Access Compliance Report Public Rights-of-Way (Curb Ramps)

Main Street: SIENNA_PKWY		Cross Street: S_DAISSY_ST		Location:	NE
ADA ID: RPRK211112114122	Ramp Type: Type 4 - Parallel	Initial Pass/Fail: Fail	Overall Compliance: No	Severity Score:	16

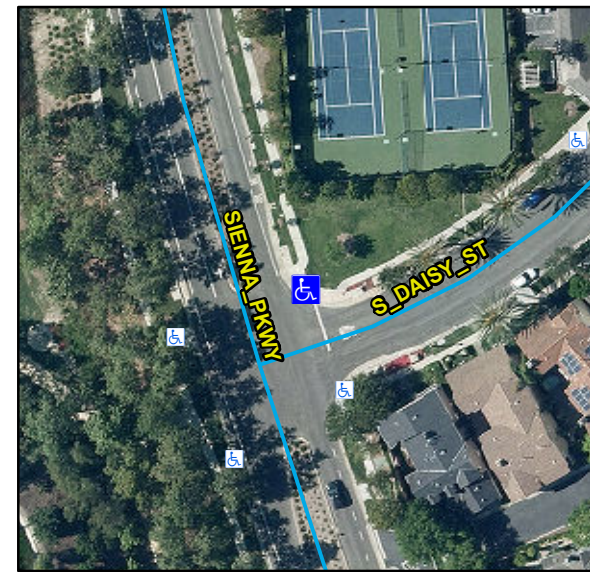
Compliance	Description	Data	Compliance	Description	Data
N/A	Ramp Length LT (in)	138	N/A	Ramp Length RT (in)	126
Yes	Ramp Width LT (in)	89	Yes	Ramp Width RT (in)	89
No	Ramp Run Slope LT (%)	10.1	Yes	Ramp Run Slope RT (%)	6.2
No	Ramp Cross Slope LT (%)	2.7	No	Ramp Cross Slope RT (%)	3.6
N/A	Landing Present	N/A	N/A	DWS Provided	N/A
N/A	Landing Length (in)	N/A	N/A	DWS Contrast	N/A
N/A	Landing Width (in)	N/A	N/A	DWS Length (in)	N/A
N/A	Landing Run Slope (%)	N/A	N/A	DWS Full Width	N/A
N/A	Landing Cross Slope (%)	N/A		DWS Offset Type	N/A
N/A	Landing Movement Obstructed?	N/A	N/A	DWS Offset Left (in)	N/A
	Landing Movement Type	N/A	N/A	DWS Offset Right (in)	N/A
N/A	Landing Shared	N/A			
N/A	Clear Space	Yes			
N/A	Clear Space To Crosswalk (in)	N/A			
N/A	Marked Crosswalk 1	No	N/A	Marked Crosswalk 2	No
	Crossing 1 Direction	W		Crossing 2 Direction	S
	Marked Crosswalk 1 Width (in)	N/A		Marked Crosswalk 2 Width (in)	N/A

Remove & Replace Curb Ramp With Two New Directional Ramps or Equivalent.

R204.3, R304.3.2, R304.5.3, STD 1115
